**GPT SUBMISSION
AMP CIRCULAR QUAY SYDNEY
50 BRIDGE STREET, SYDNEY**

Re: DA – D/2013/1942 Stage 1 DA for the AMP Circular Quay Precinct

Figure 1 – Extract from Visual Impact Report by BVN Donovan Hill (View 17) which understates the proposed view impact

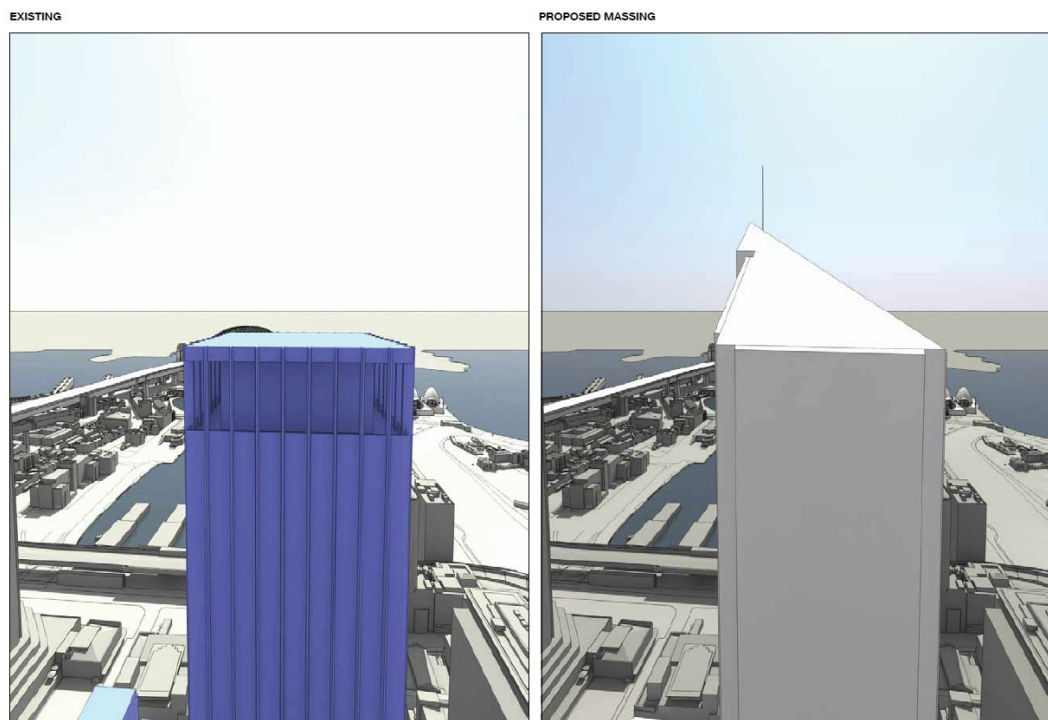
An inspection of the upper levels of GPT shows that this assessment is incorrect. The following images compare the image relied upon by BVN/Urbis (**Figure 1**) with the actual views from the upper levels of GPT (**Figures 2 to 4**). The comparison illustrates and that the existing view to the Harbour Bridge and greater harbour from the upper levels of GPT are expansive and that the view impact for Levels 58 to 61 (four levels) of GPT will be devastating.

Figure 2 – Existing northern view from Level 61 of GPT which will be severely affected by the proposed additions to 50 Bridge Street

Figure 3 – Existing northern view from Level 60 of GPT will be severely affected by the proposed additions to 50 Bridge Street

Figure 4 – Existing northern view from Level 58 of GPT will be severely affected by additions to 50 Bridge Street

Figure 5 – Existing northern view from Level 57 of GPT will be partially affected by the proposed additions to 50 Bridge Street

To ensure that view impacts are properly considered in the assessment of the DA, the applicant must prepare view montages that rely upon actual photographs taken from the upper levels of GPT and that clearly identify the viewing position. More details on the view impact assessment follow in point 2 and 3.

- 3) Removal of the 10% bonus FSR from the Stage 1 DA building envelope.
- 4) Articulation of how much “fat” is provided for in the building envelope.
- 5) A more accurate assessment of the view impact for the upper levels of GPT using photographs and clearly identifying where the photographs were taken from.
